Canterbury Earthquakes Royal Commission

Re: 7 Riccarton Road

Canterbury Earthquakes Royal Commission – 7 Riccarton Road - response by David Elliott, Senior Structural Engineer with Aurecon New Zealand Limited, to Royal Commission's request for information dated 30 August 2011

Canterbury Earthquakes Royal Commission – 7 Riccarton Road - response by David Elliott, Senior Structural Engineer with Aurecon New Zealand Limited to Royal Commission's letter dated 30 September 2011.

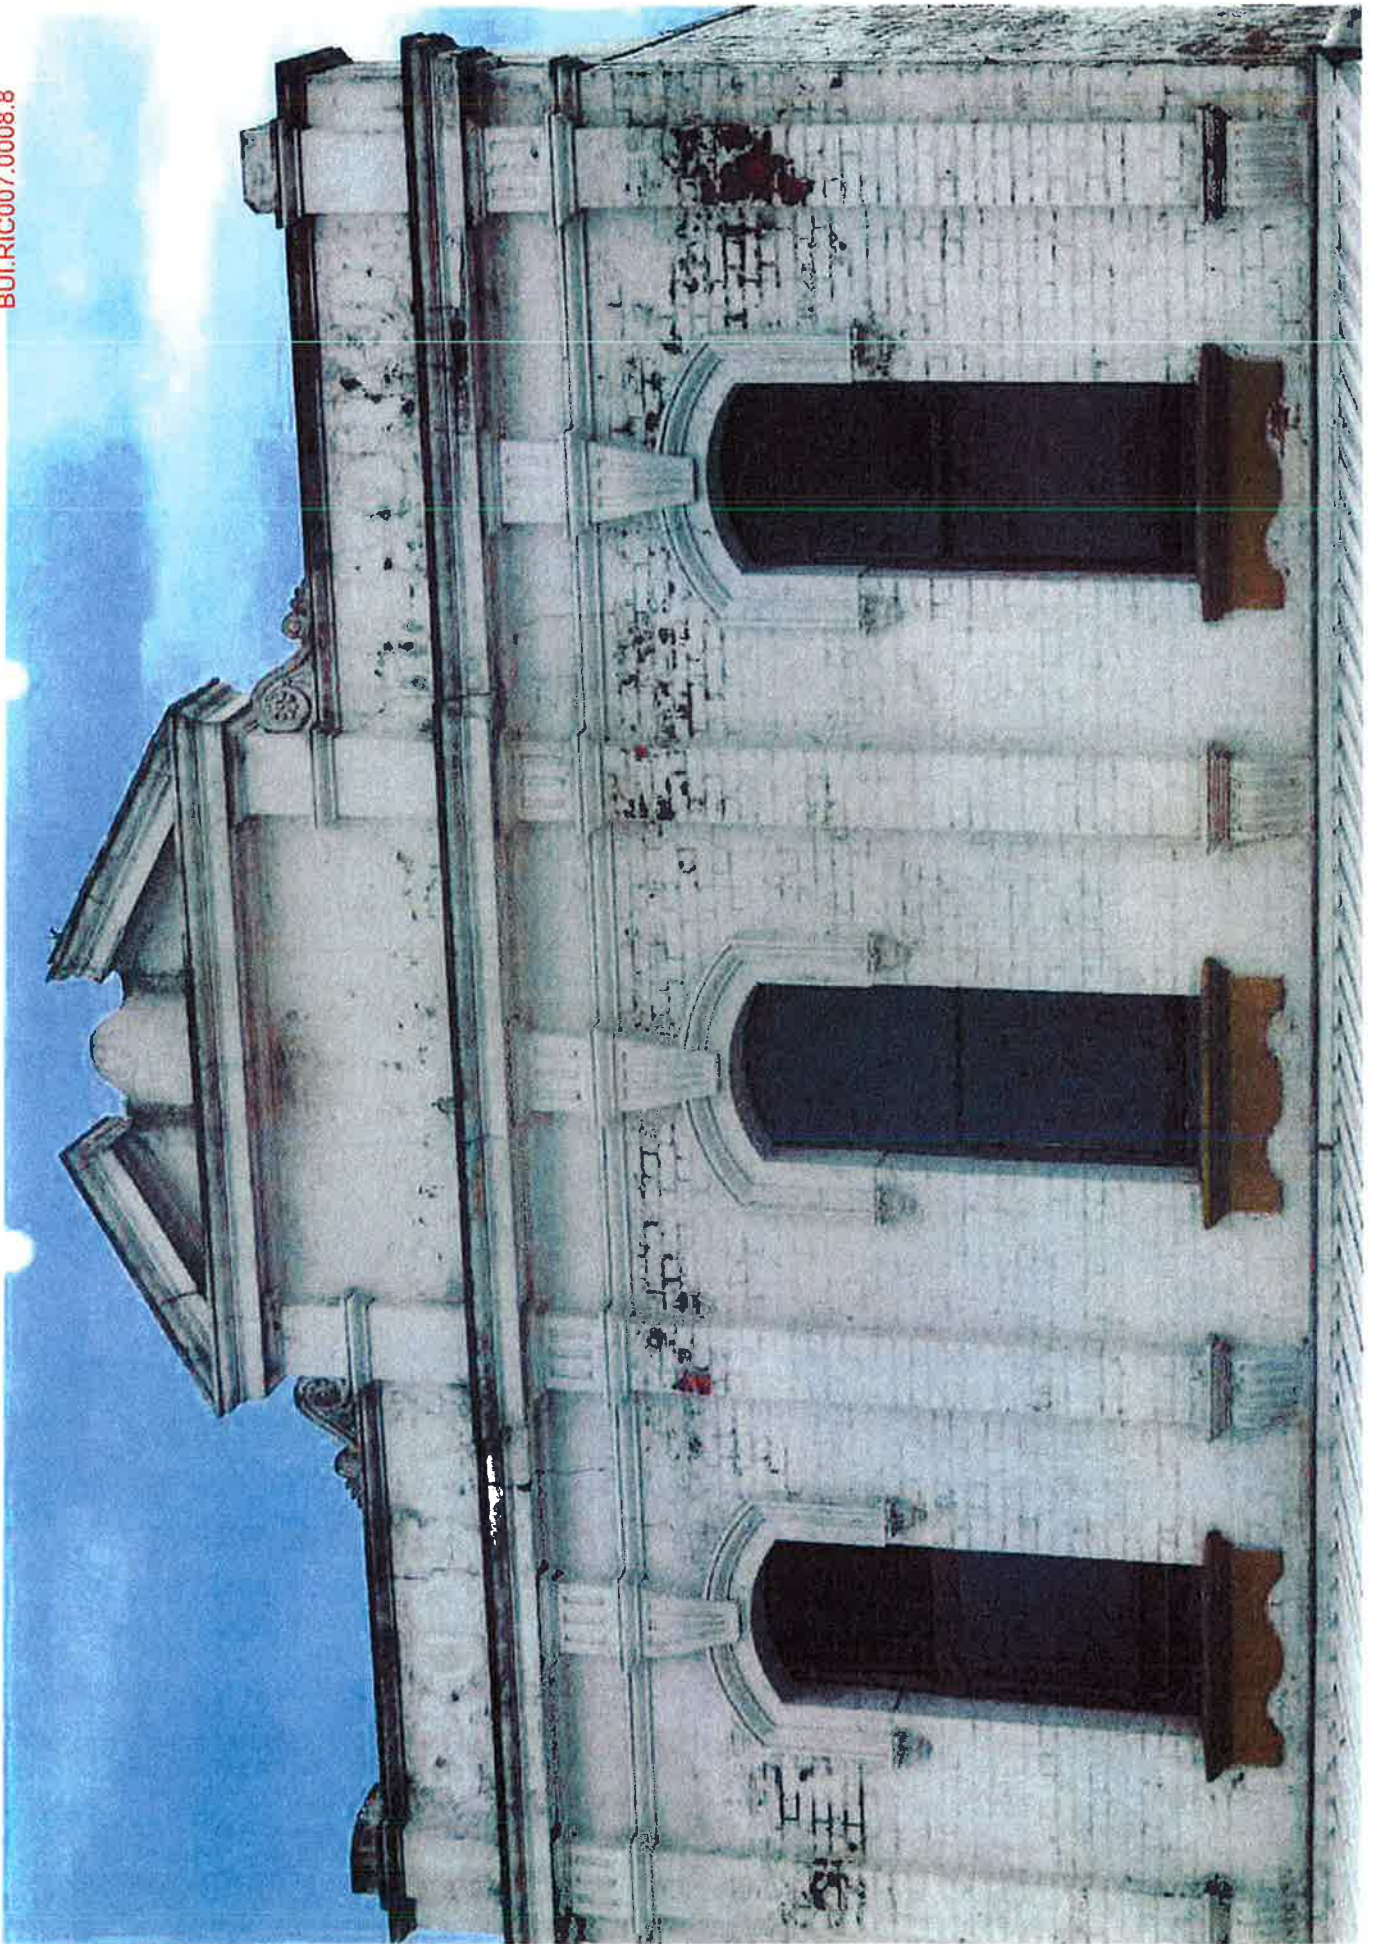
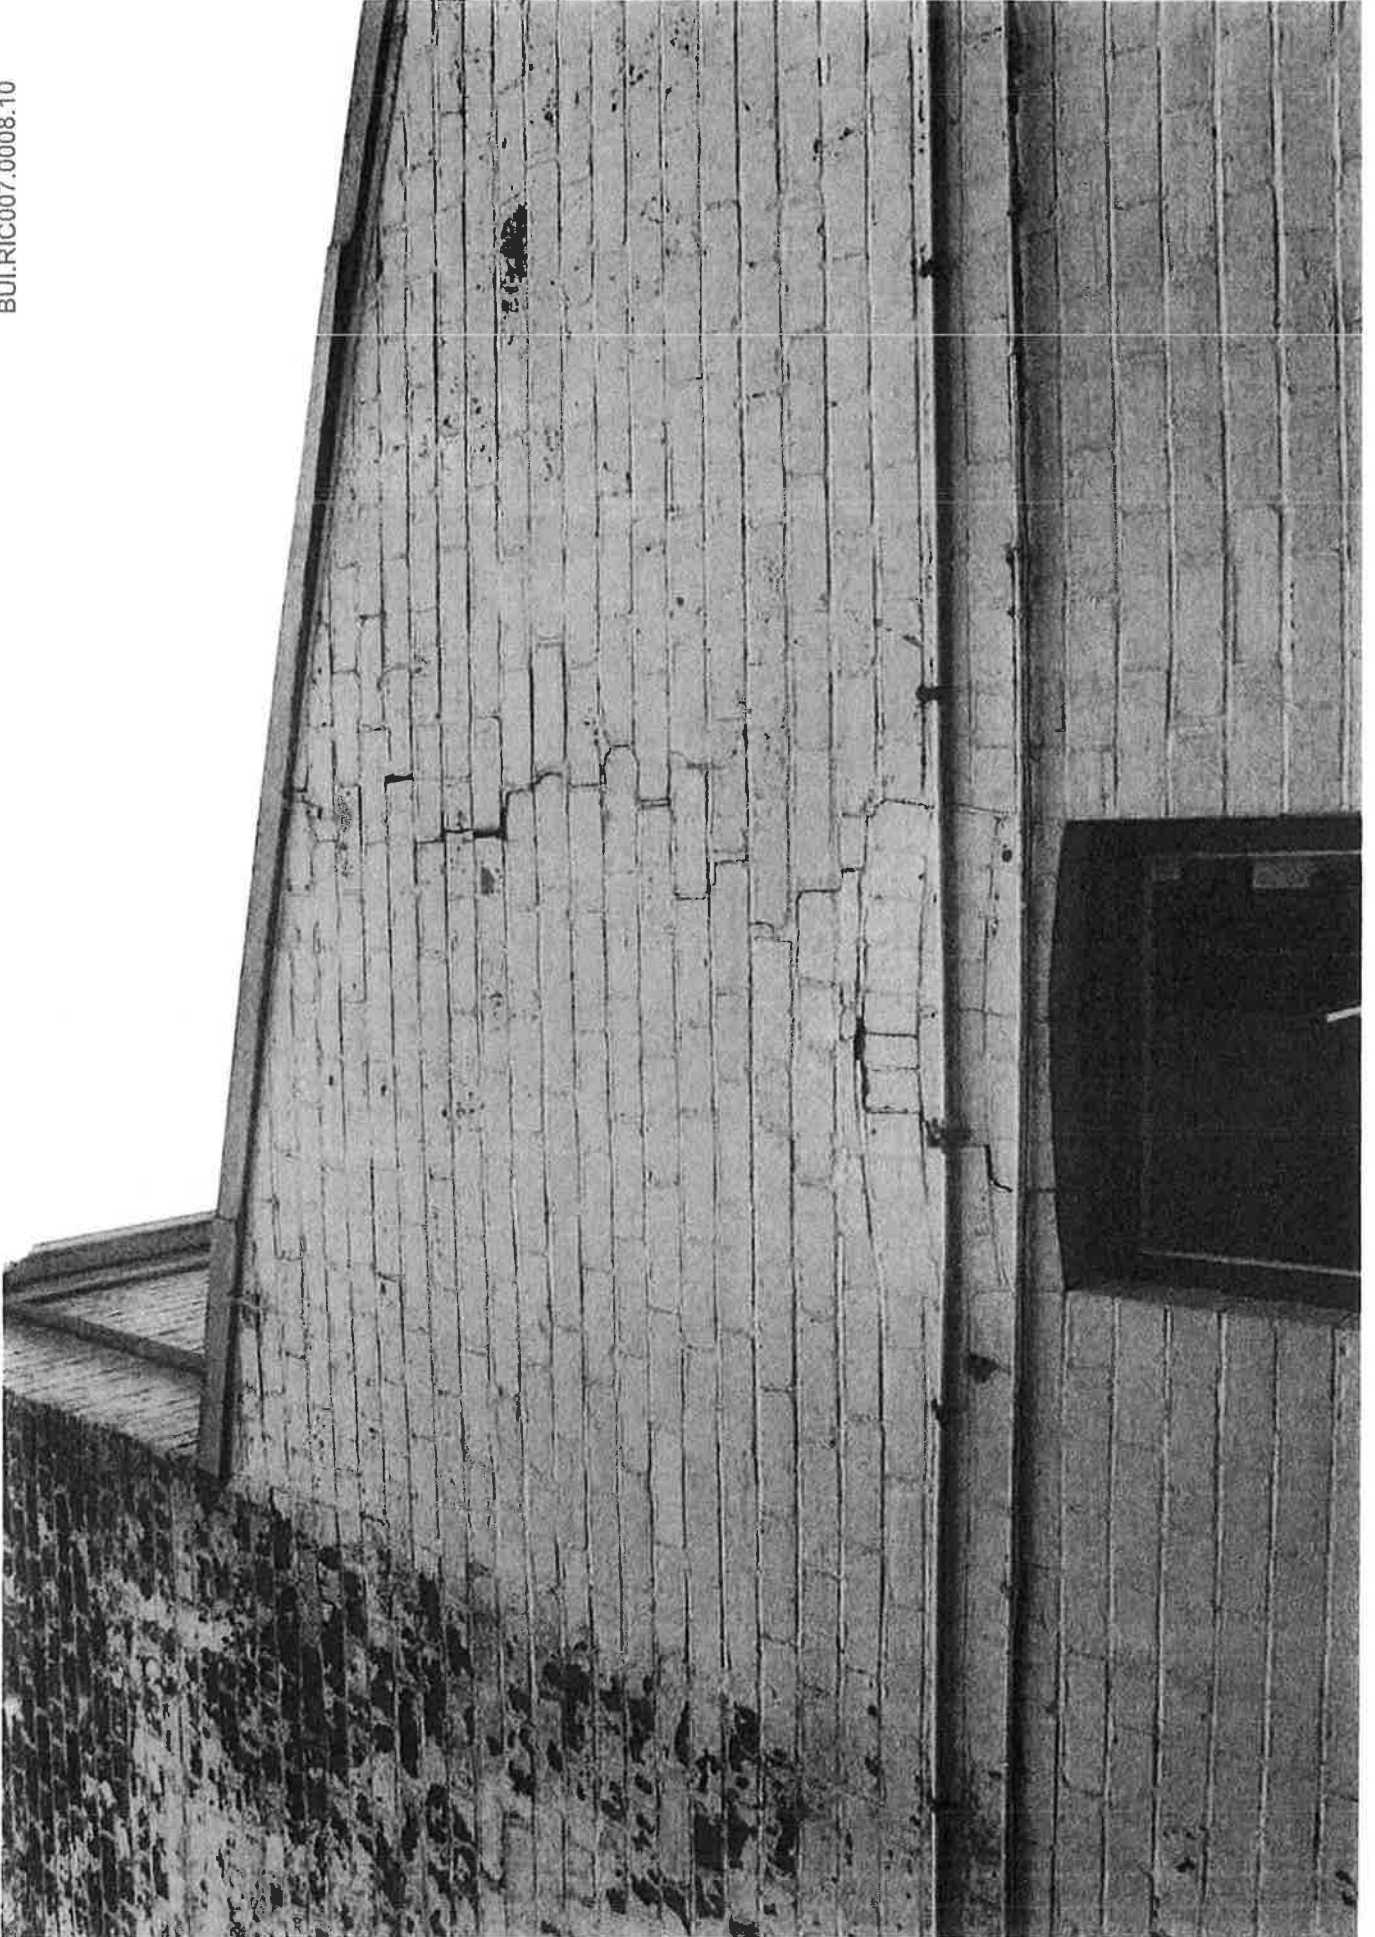
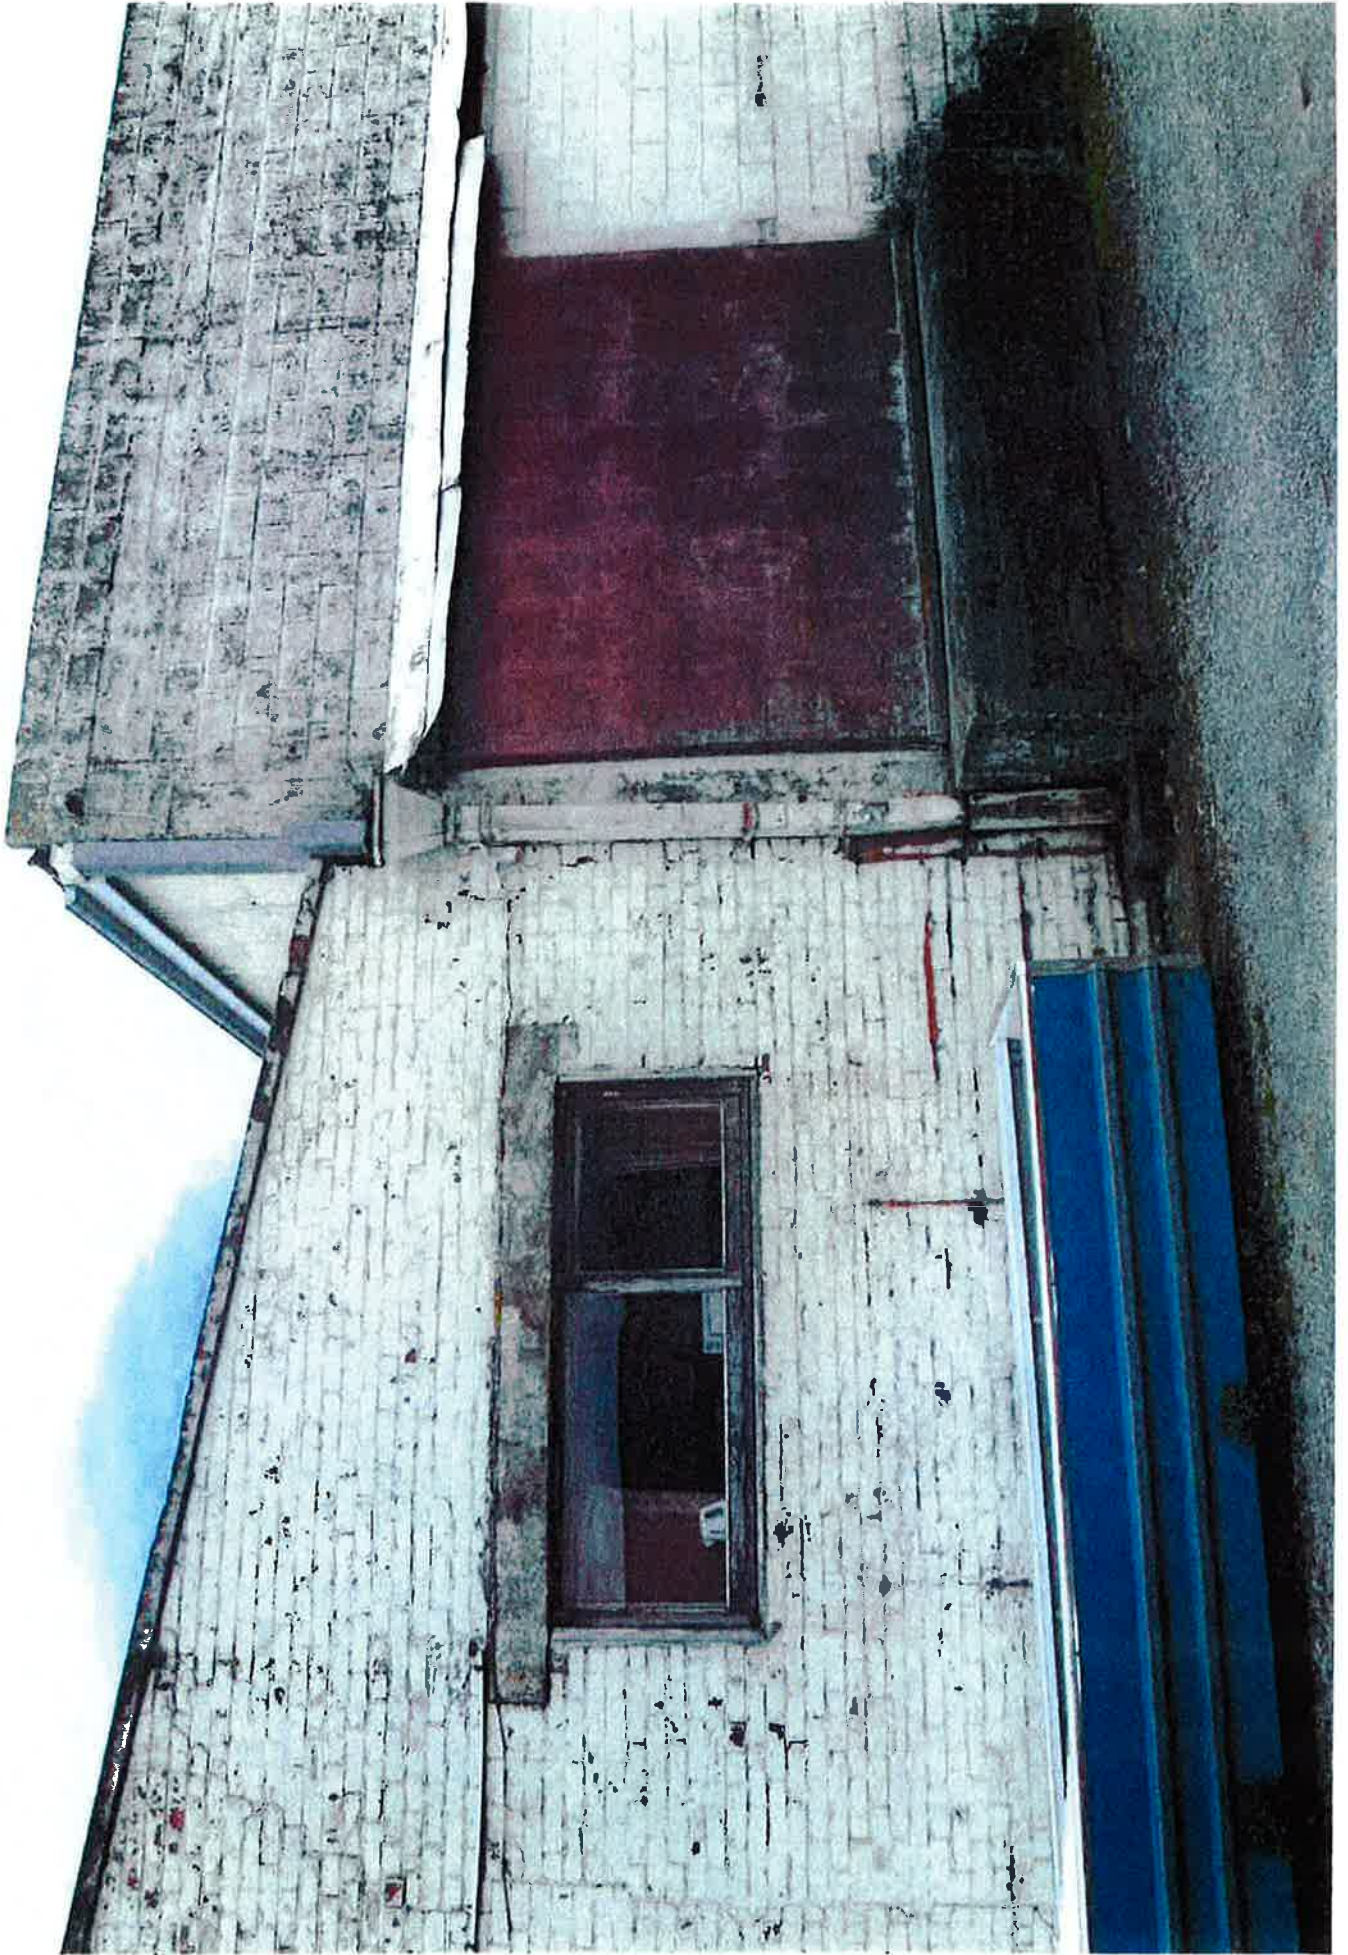
4. The Council Rapid Assessment Form dated 11 September 2010 (and the yellow placard affixed to the building) noted:

"large crack in front façade and parapet. Engineer to inspect and advise"

- a) Did you inspect the crack in the front façade and parapet subsequent to 11 September 2010? If so, please provide details of what you observed and the conclusions you came to. If not, please explain why not.

- 4.1 Yes – on or about the 17th September 2011. The cracking I observed was not what I would describe as large and it appeared to be consistent with what I had seen during my previous inspections - the condition had not worsened. I did not observe what I would describe as a large crack in the front façade and parapet. I have located photos on my lap top that were taken of the building during my first inspection. I can make those available. The cracking I saw on or about the 17th September is as recorded in these photos.
